# Waterwood

## MASTER PLAN

INFORMATION SHEET FOR  
PRELIMINARY OVERALL AREA DEVELOPMENT PLAN

Re: Waterwood POADP  
Plan #310

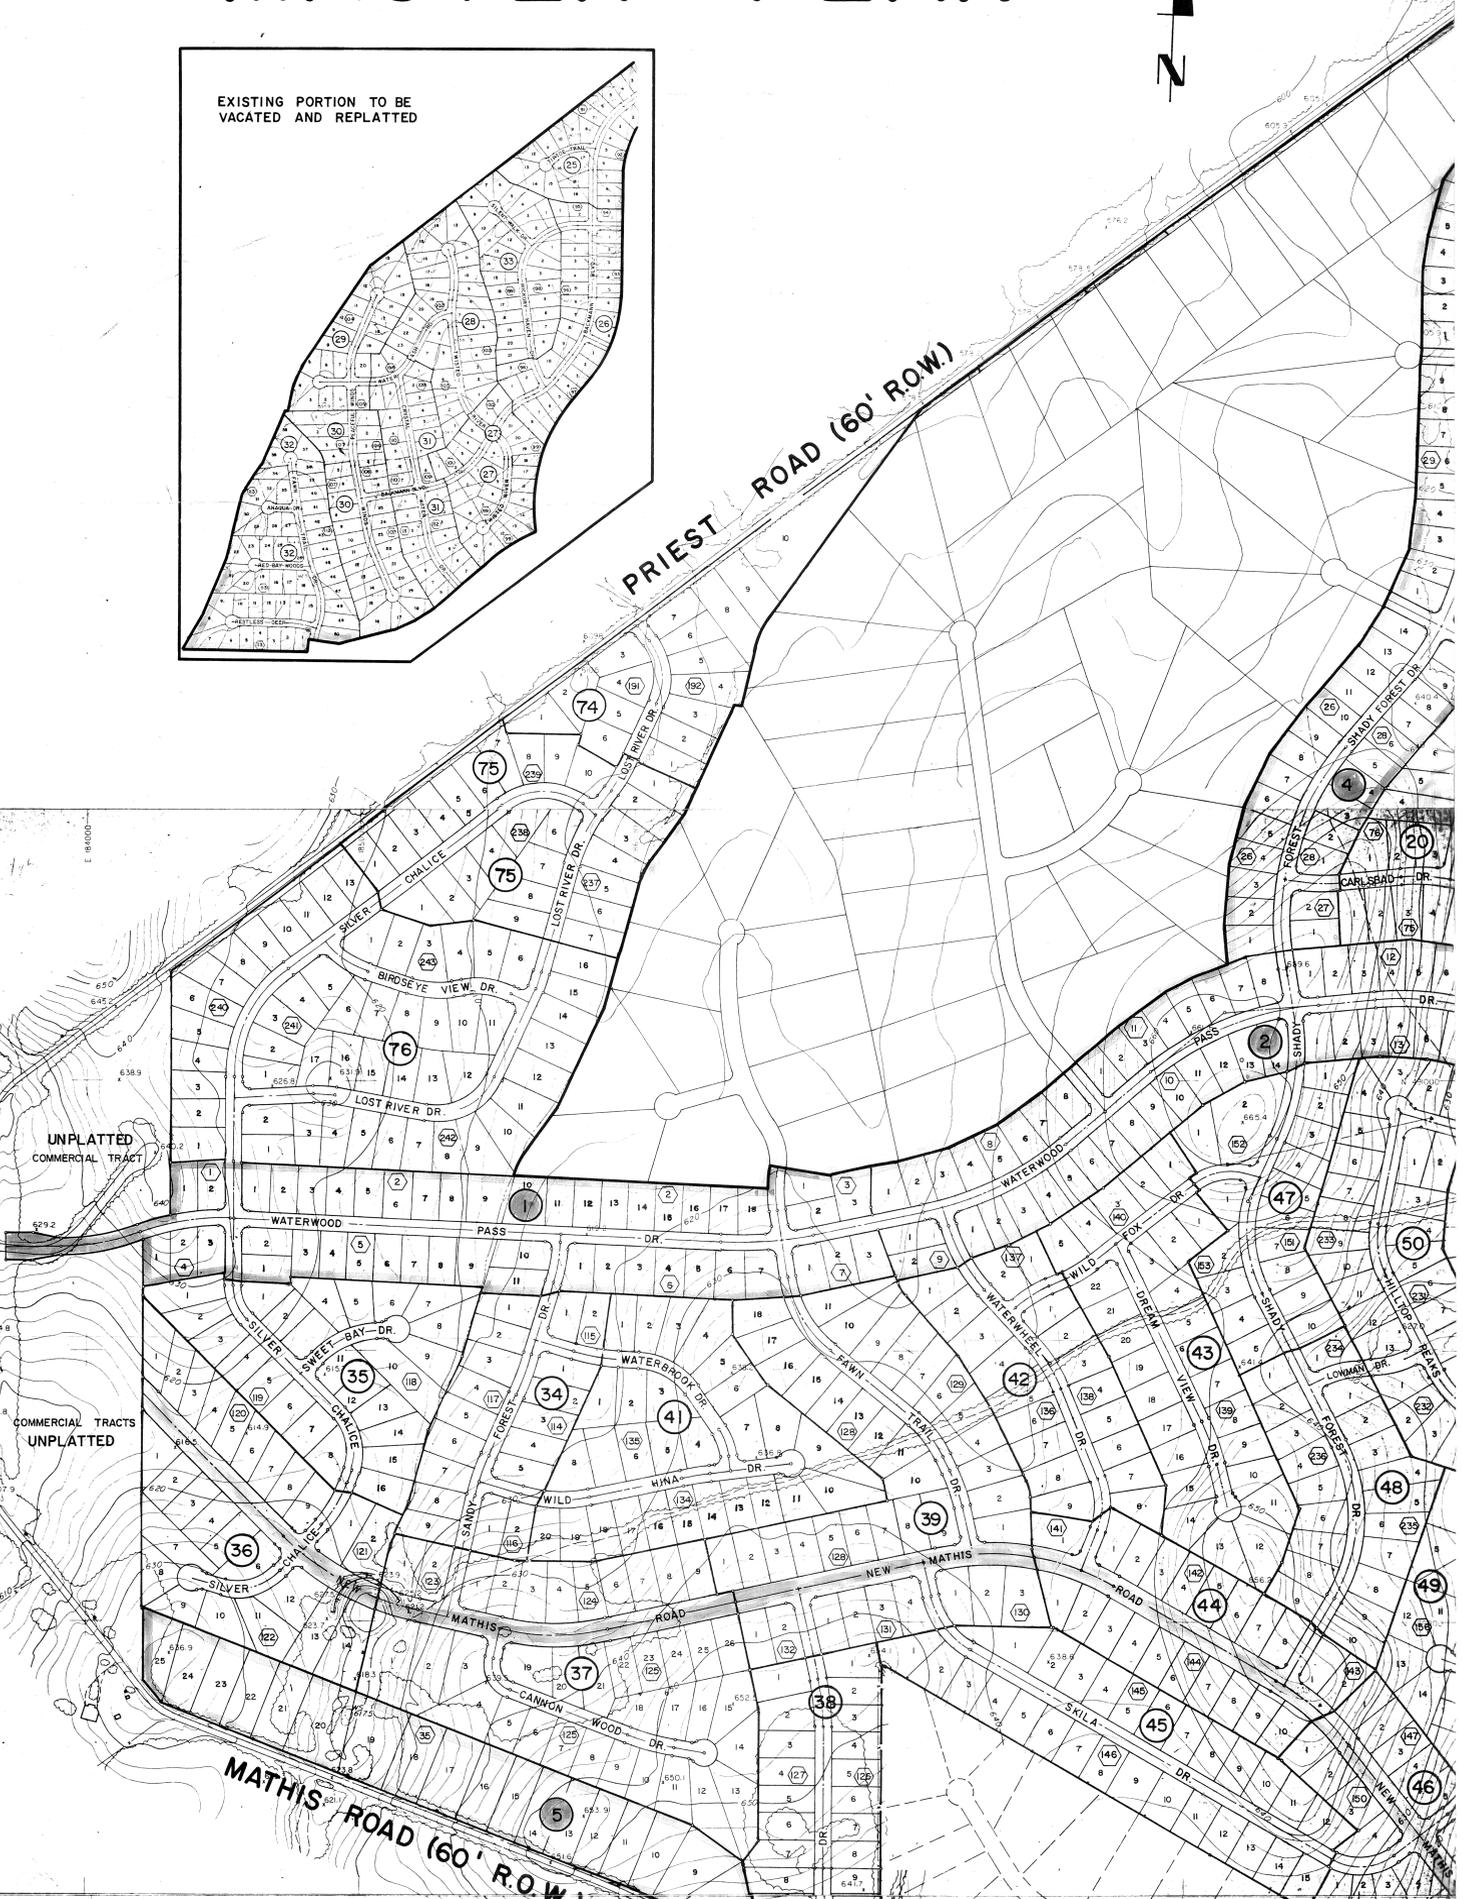
Your proposed plan for Waterwood is lacking certain data as required by the Unified Development Code. I was unsuccessful in reaching you by phone. If there is another number where I can call you, then please provide us with that information.

Specifically, the code requires that you show proposed land uses by location, type and acreage. Row widths of existing adjacent or perimeter streets. The limits of the 100 year flood plain as identified from the most current FEMA maps. Location map indicating the location and distance to adjoining streets and at least two (2) major thoroughfares. The name and address of the developer. Finally, identify existing or proposed collector, arterial and or local type B streets and their relationship to any major thoroughfare.

Please revise your plan and resubmit 6 new copies of the plan for committee review.

PROPOSED LOT DESIGN AND STREET LAYOUT

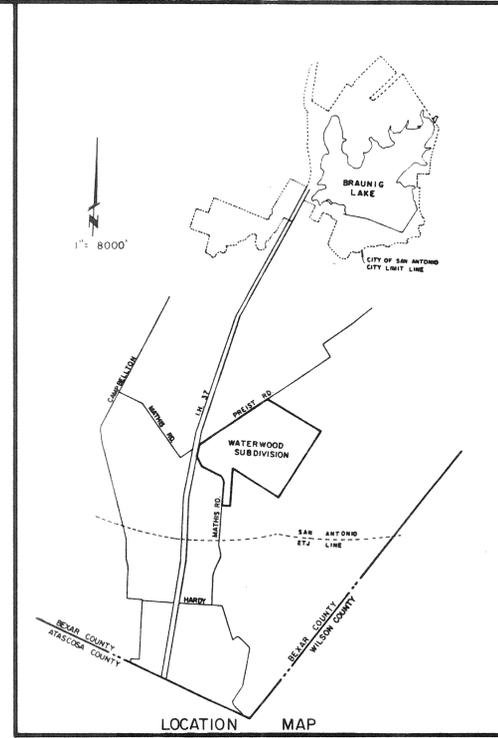
The Development Review Committee reviewed your plan of Waterwood and assigned file #310 for future reference. The area proposed to be resubdivided includes a cul-de-sac street in access of 2000' ft. in length and a local type street located off of Shady Forest Dr. dead ends onto this site. Staff recommends the long cul-de-sac street either be extended to Priest Rd. or looped around to tie into Shady Forest Dr. The dead end street will require a cul-de-sac upon formal plat filing. The plan will be held in abeyance pending your response.
